Office Action Summary	Application No. 10/518,820	Applicant(s) FONTENEAU ET AL.	
	Examiner JASON L. LAZORCIK	Art Unit 1791

DETAILED ACTION

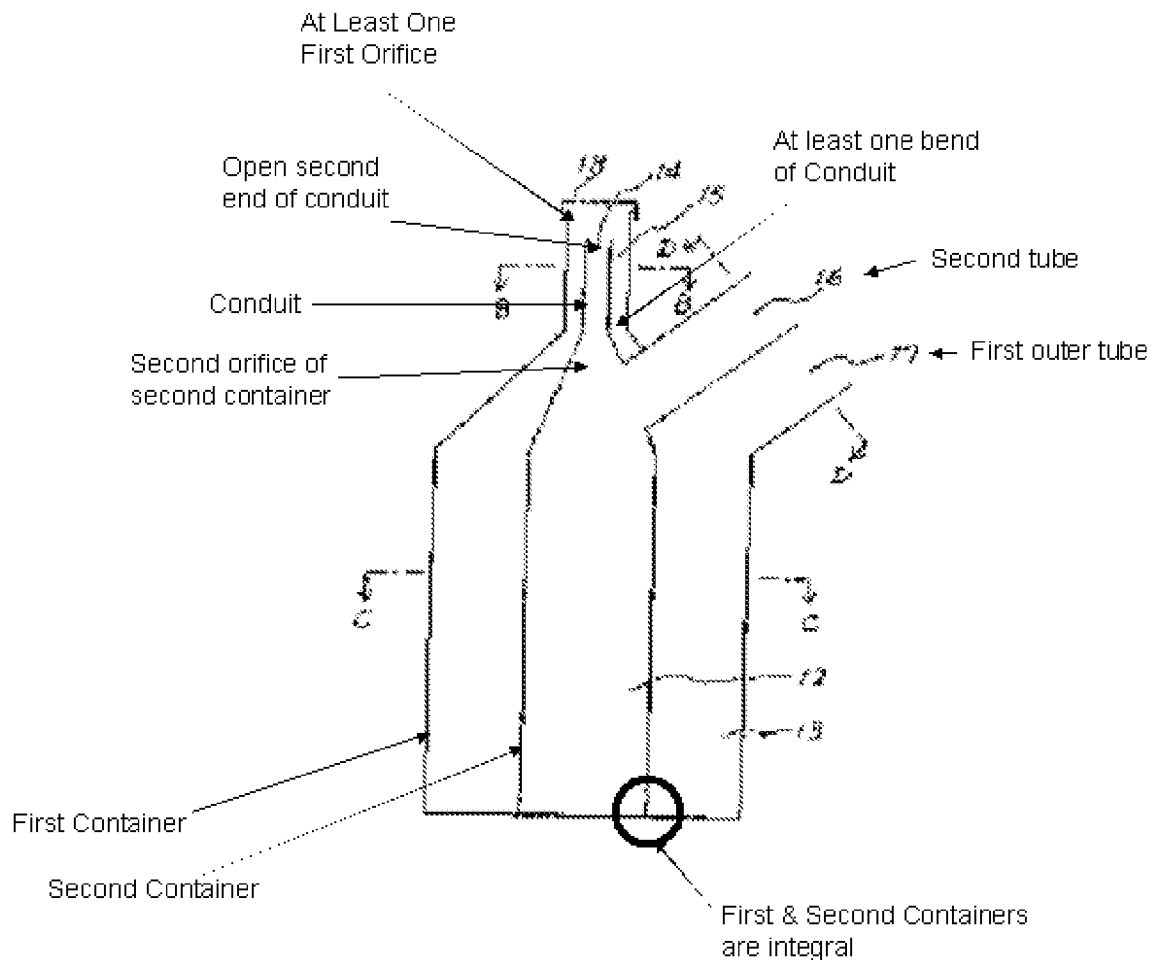
Regarding independent **Claim 1** and with particular reference to the embodiment depicted in the instant reference figures 4a-d (see annotated figure 4a excerpt below), Mitachi teaches a chamber comprising a substantially closed first container (13) which comprises at least one "first orifice" in the region of lead line (15). A substantially closed second container (12) is positioned inside and is integral with the first container. As noted in the figure, a "second orifice" connects the second container to a first end of "a conduit", which conduit is understood to be integral to said second container. This conduit further comprises a "second open end", as noted, which is inside the first container and which is aligned with and at a distance from said first orifice.

Regarding **Claim 14**, the second container and conduit are inside the first container (see fig. 4 excerpt below)

Regarding **Claim 15**, the conduit comprises at least one bend as noted in the figure 4 excerpt

Regarding **Claim 20**, Mitachi teaches a first outer tube (17) as noted in the figure 4 excerpt below

Regarding **Claim 21**, Mitachi teaches a second tube (16) as noted in the figure 4 excerpt.
